NORTH ANNA UNITS 1 AND 2  
TECHNICAL SPECIFICATION CHANGES  
FOR  
2905 MWt NSSS RATING

VIRGINIA POWER

JANUARY 1985

North Anna Core Upgrading  
(2893 MWt RATED THERMAL POWER)

Figure 2.1-1 REACTOR CORE SAFETY LIMITS FOR THREE LOOP OPERATION

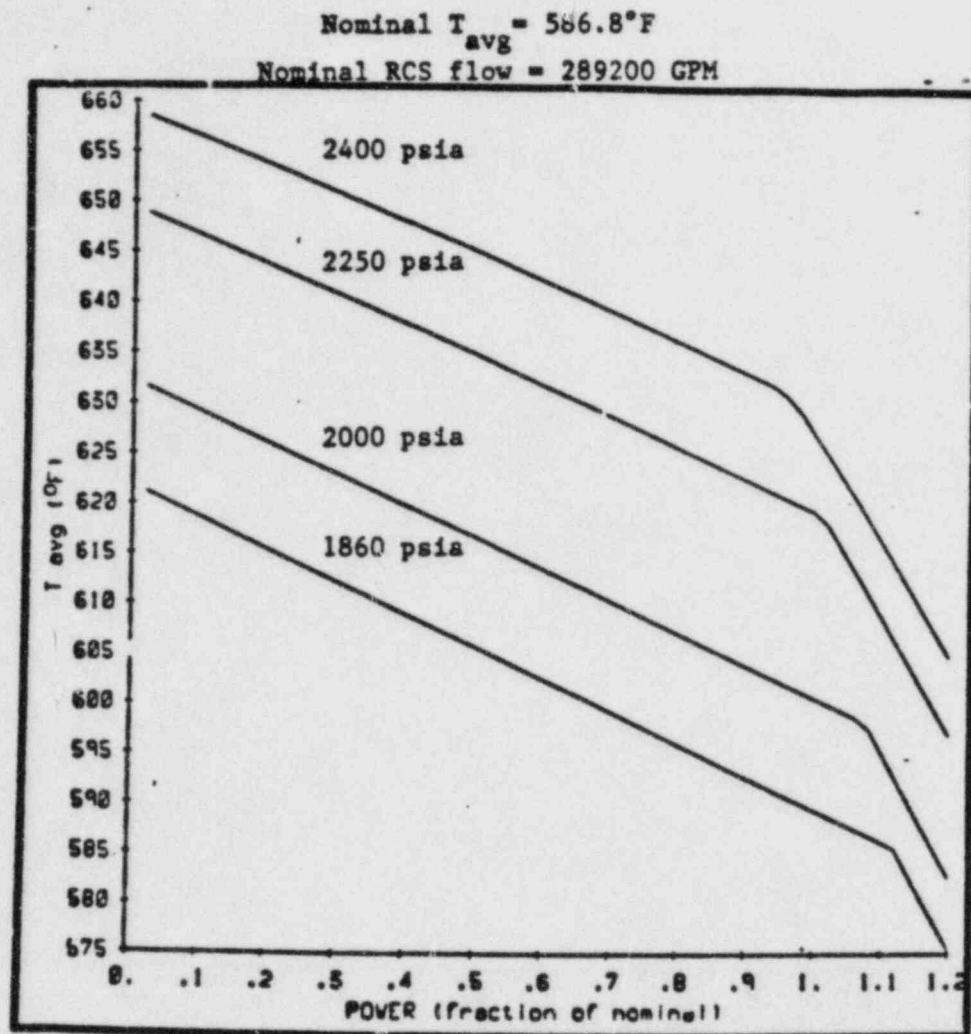
The curves of Figures 2.1-1, 2.1-2 and 2.1-3 show the loci of points of THERMAL POWER, Reactor Coolant System pressure and average temperature for which the minimum DNBR is no less than the design limit DNBR, or the average enthalpy at the vessel exit is equal to the enthalpy of saturated liquid.

Figure 3.2-2 NORMALIZED  $F_Q(z)$  AS A FUNCTION OF CORE HEIGHT

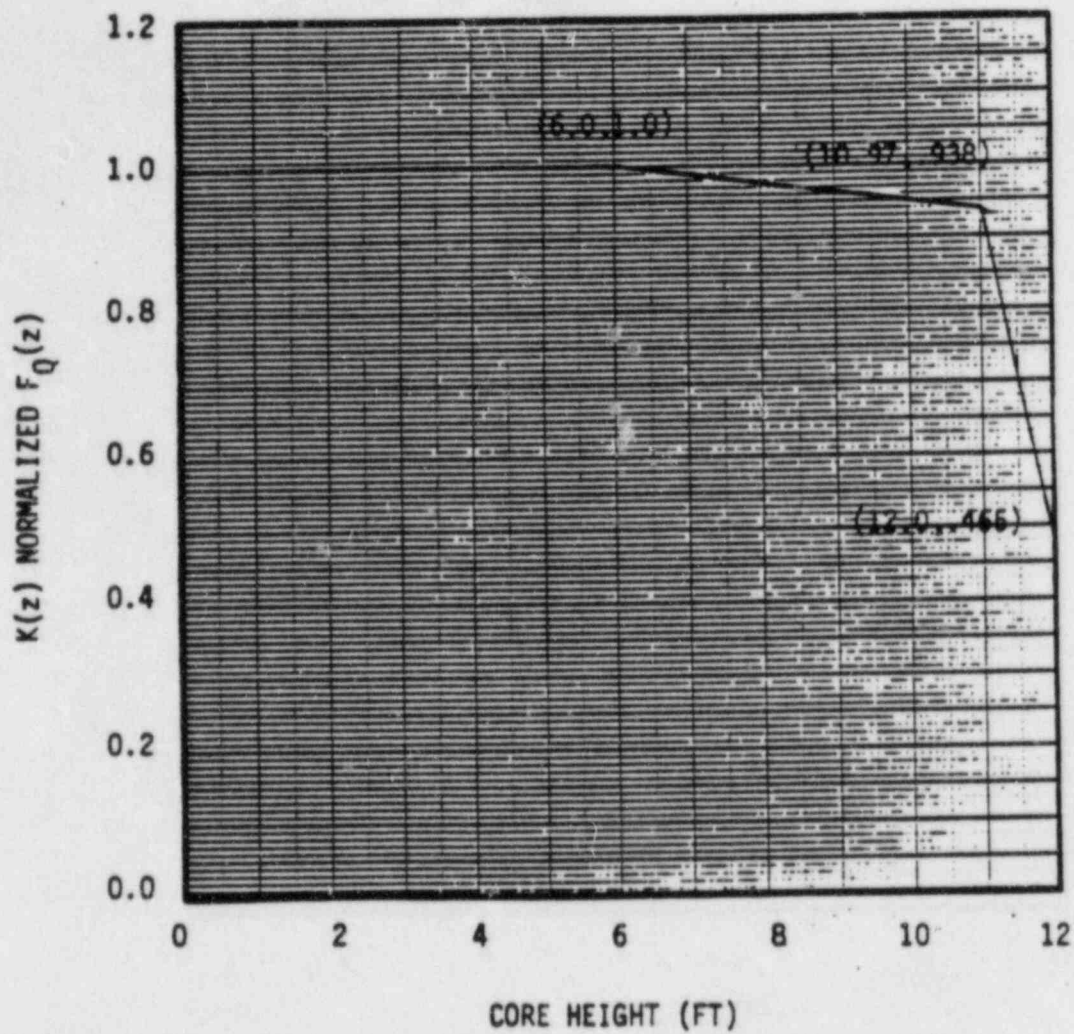
and  $K(Z)$  is the function obtained from Figure 3.2-2 for a given core height location.

Figure 2.1-1 REACTOR CORE SAFETY LIMITS FOR THREE LOOP OPERATION

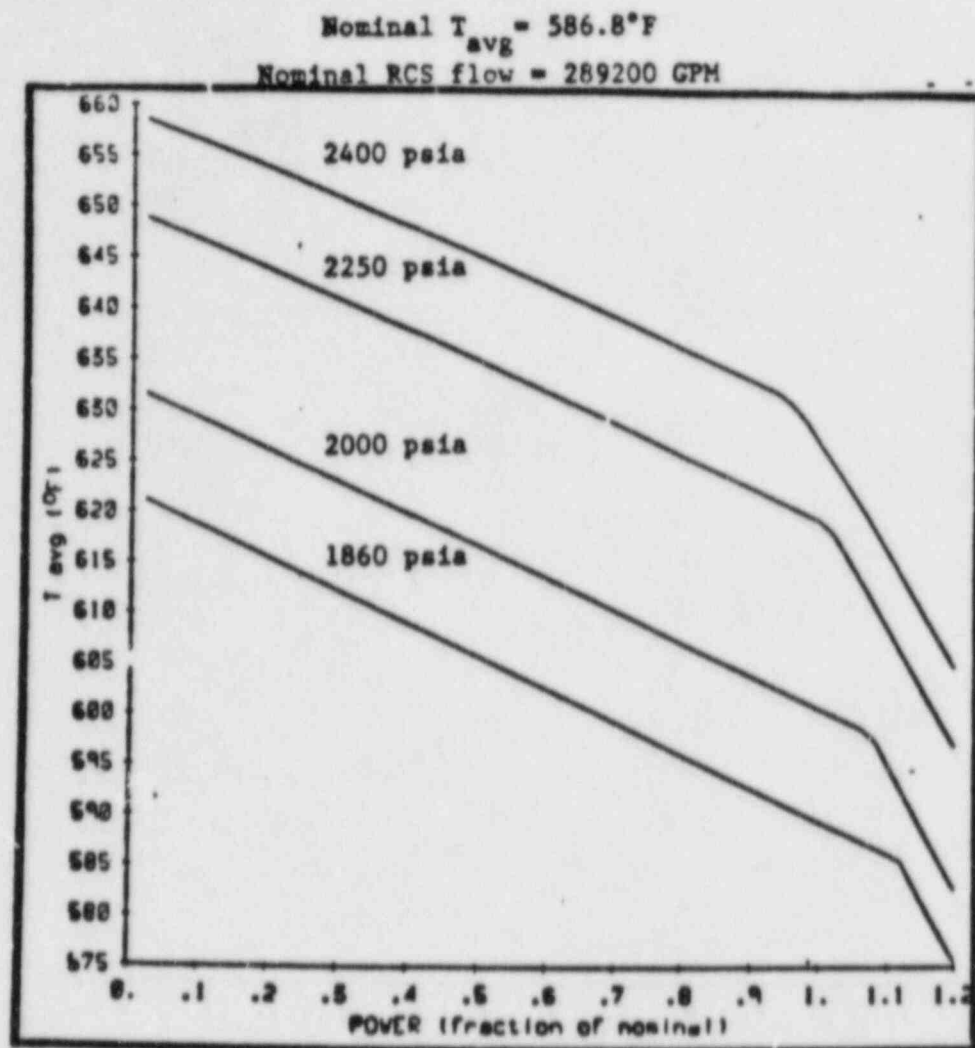
The curves of Figures 2.1-1, 2.1-2 and 2.1-3 show the loci of points of THERMAL POWER, Reactor Coolant System pressure and average temperature for which the minimum DNBR is no less than the design limit DNBR, or the average enthalpy at the vessel exit is equal to the enthalpy of saturated liquid.

Figure 3.2-2 NORMALIZED  $F_Q(z)$  AS A FUNCTION OF CORE HEIGHT

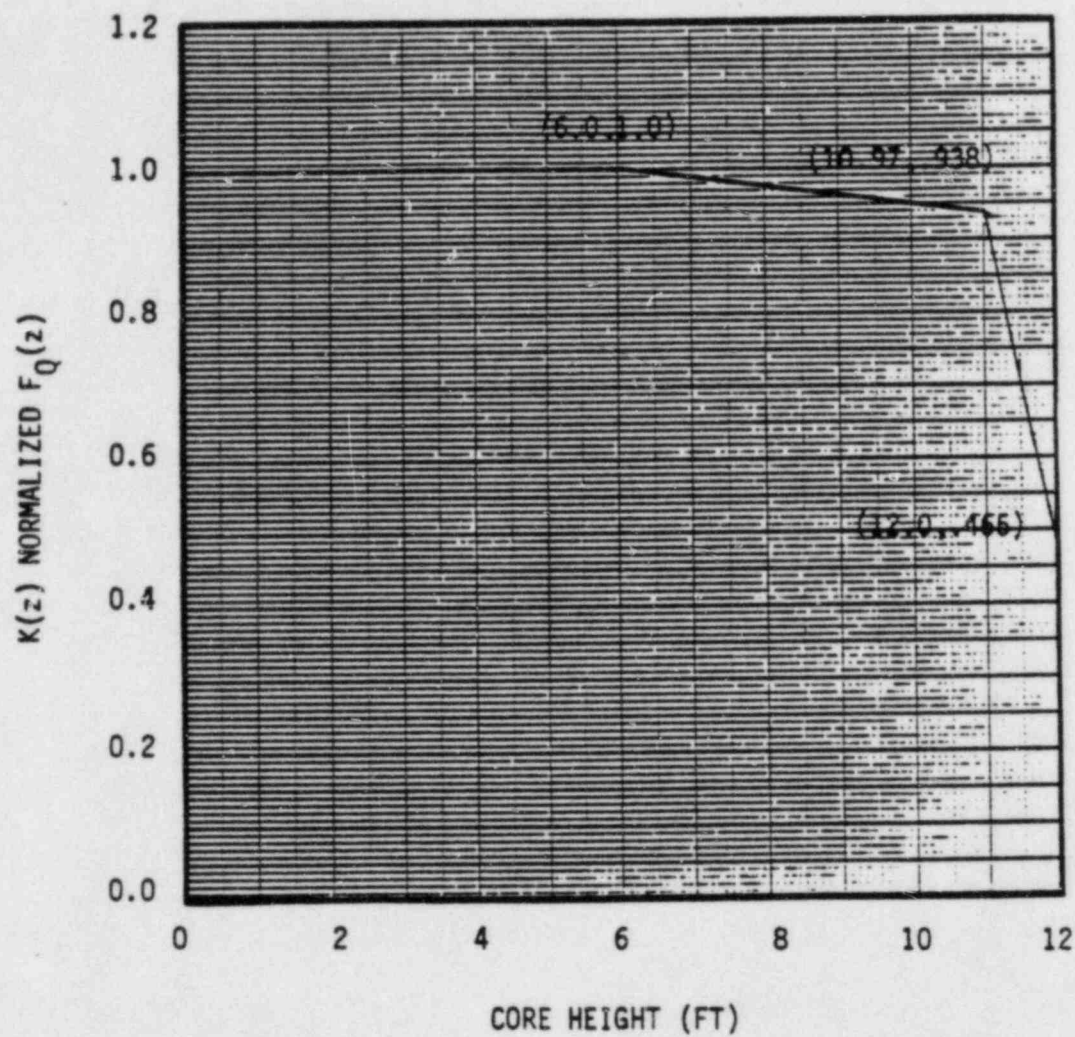
and  $K(Z)$  is the function obtained from Figure 3.2-2 for a given core height location.
